# 6 Series Indoor Stations Version: V2.1.58\_build220815 Release Note (2022-08-23)

# 6 Series Indoor Stations Version: V2.1.50\_build220720 Release Note (2022-07-20)

# 6 Series Indoor Stations Version: V2.1.44\_build220516 Release Note (2022-05-22)

# 6 Series Indoor Stations Version: V2.1.38\_build220228 Release Note

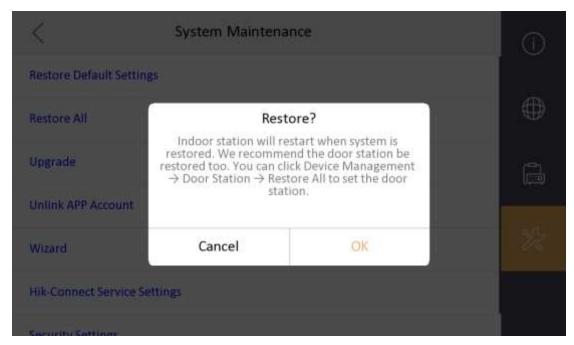
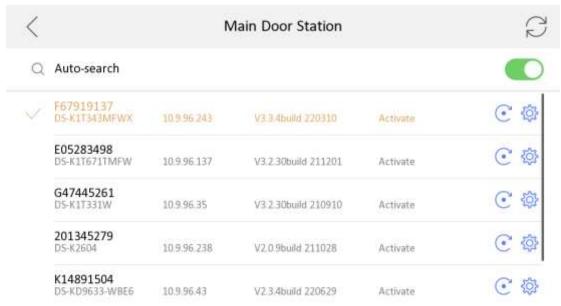
1. Fix the indoor station maintenance interface. When click restore or restore all, a prompt information will pop.

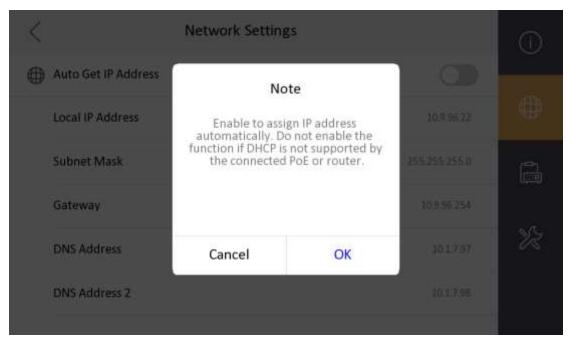
2. The indoor station wizard-related devices added the effect of selecting the door station.

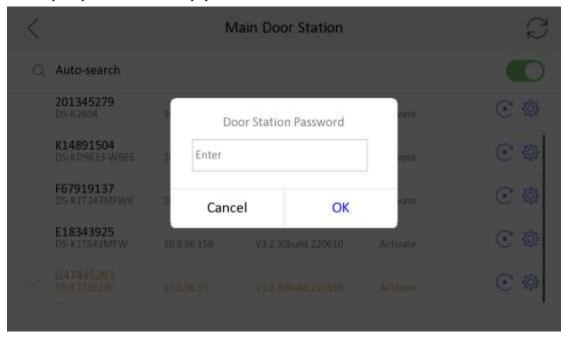
3. Add a prompt information when assign network IP address automatically.

4. In configure wizard to related door station, when the door station password is different from the indoor station, prompt information will pop.
